GENERAL ELECTRIC

October 8, 1979

Ref: Certificate of Compliance No. 5980

REVISIONS TO THE G. E. MODEL 600 DRAWINGS

STRESS SUMMARY TABLE

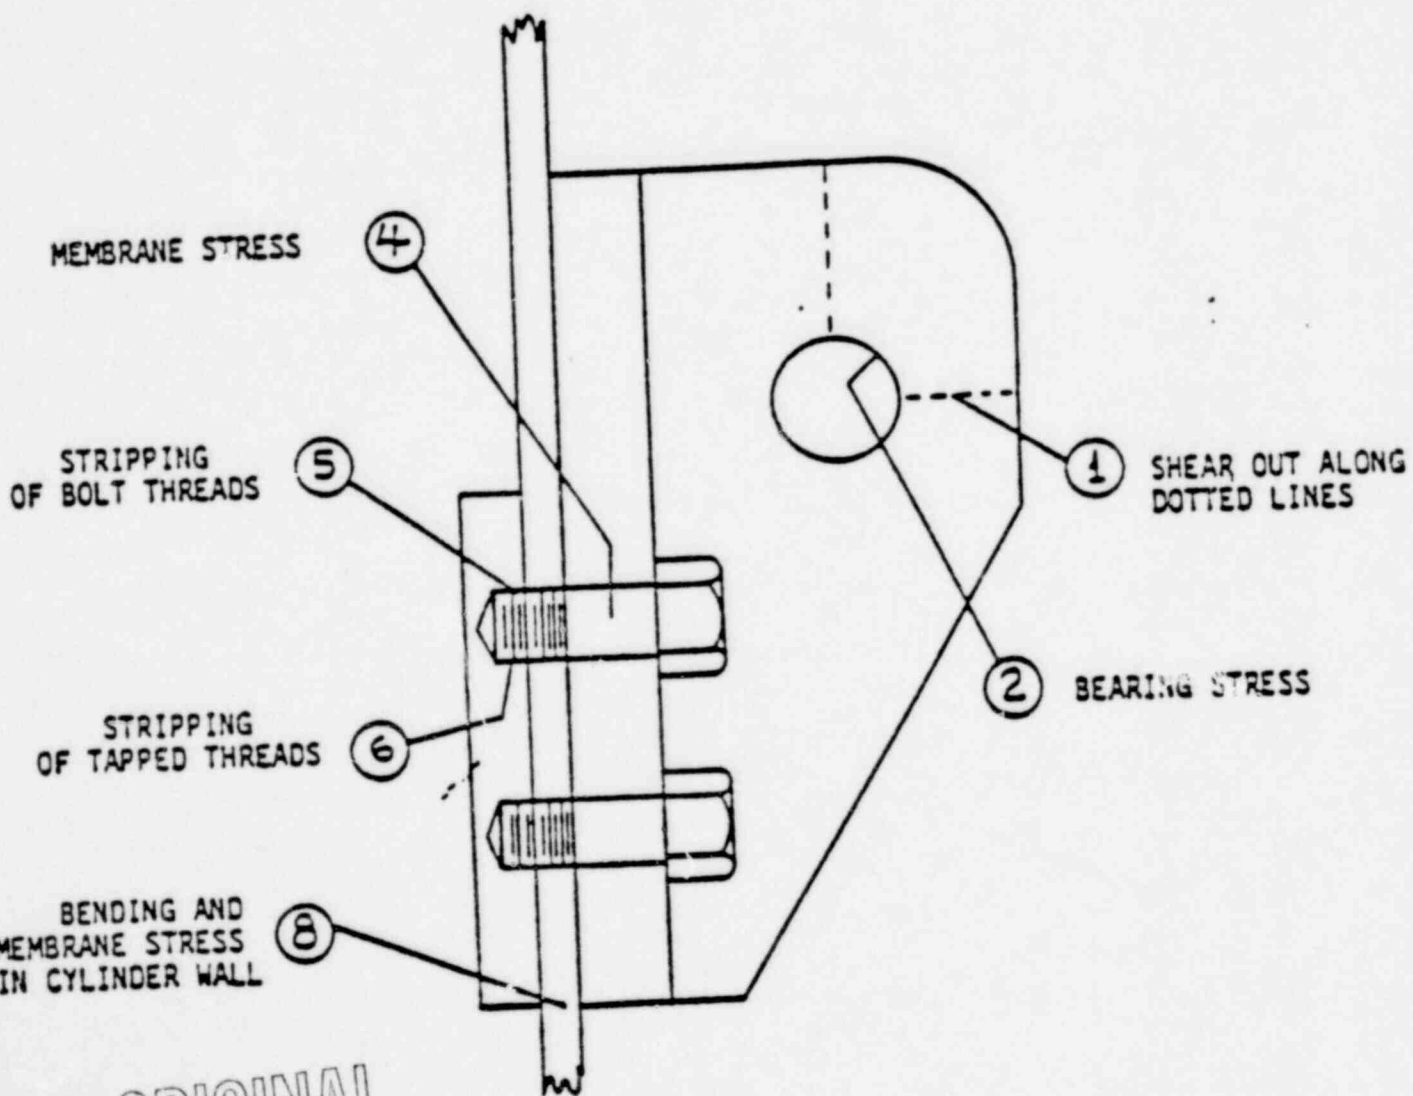
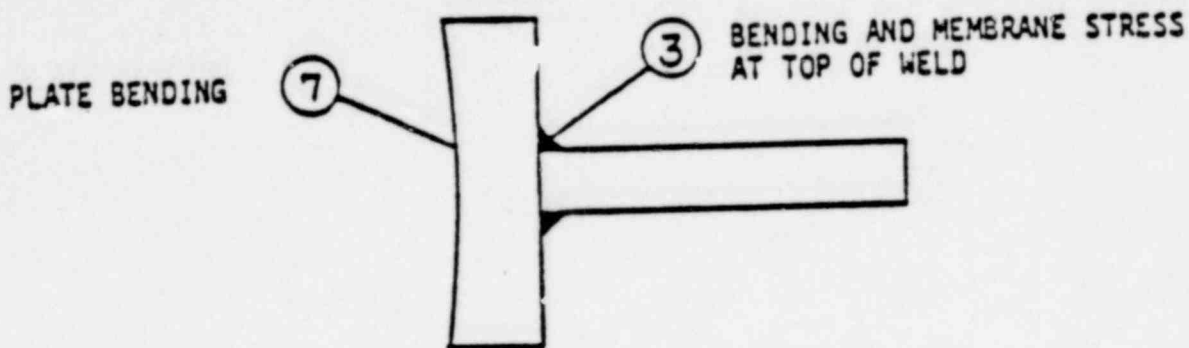
<u>LOCATION**</u>	<u>ASME CODE STRESS CATEGORY</u>	<u>STRESS LEVEL -KSI</u>	<u>ALLOWABLE STRESS -KSI</u>	<u>MARGIN WRT ALLOWABLE</u>
1	P_m	13.65	22.50	+39%
2	Bearing*	16.62	22.50	+26%
3	$P_m + P_b$	11.00	22.50	+51%
4	P_m	32.4	63.75	+47%
5	P_m	18.4	63.75	+71%
6	P_m	12.8	22.50	+43%
7	$P_m + P_b$	6.46	22.50	+71%
8	P_m	9.774	22.50	+57%
8	$P_m + Q_b$	35.23	60.00	+41%

*Assumed lifting hook diameter is 1.375 inches. If smaller diameter hooks are used the bearing stress allowable will be exceeded.
